Staff Report Memorandum

To: Planning Commission
From: Community Development Department
Subject: Sandy Station Townhomes
Preliminary Cairns Site Plan and Subdivision Review
8925 S. Harrison St.
(Community #1, Northwest Exposure)

SPR05132025-006965
SUB05132025-006966
RC Zone
Cairns District
63 Units, 3.71 Acres

Master Plan Details

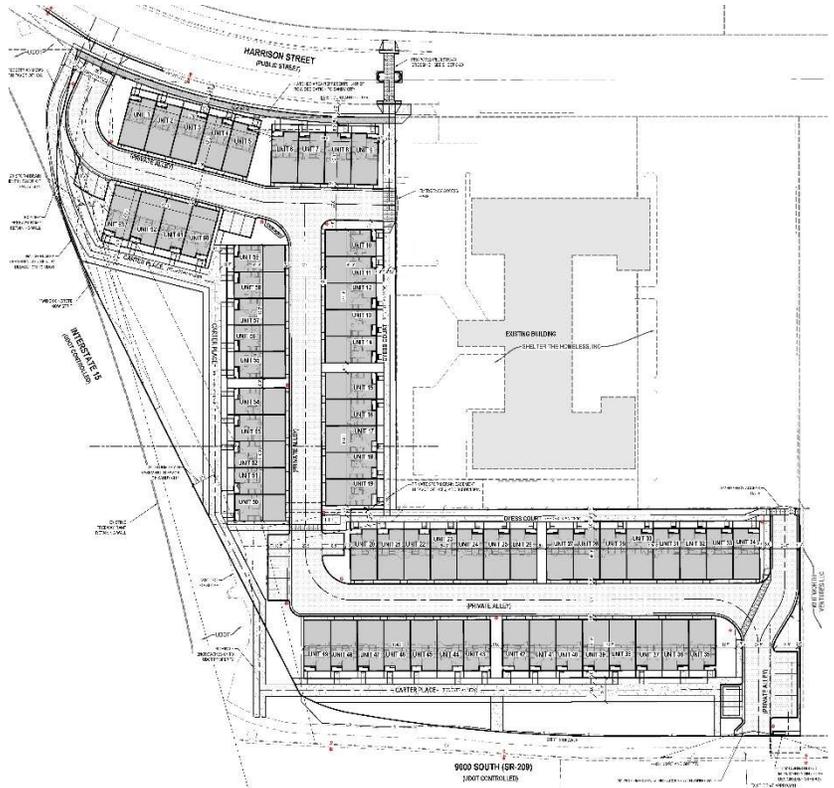
This property is shown as being part of the North Village within the Cairns District. This area is intended to become a walkable mixed use area in which residents may walk to work, shopping and recreational facilities. While this single development alone won't accomplish this goal, the overall master plan

The proposed development is for 63 residential townhome units. Some townhomes will front Harrison Street, and the rest of the units will front onto private pedestrian streets or mews, Dyess Court and Carter Place. All units are rear loaded with two-car garages accessed from a central alley. A total of 23 shared guest parking stalls that are dispersed around the development are also accessed from this alley. The alley is designed to connect to the surrounding developments to provide reciprocal vehicular access.
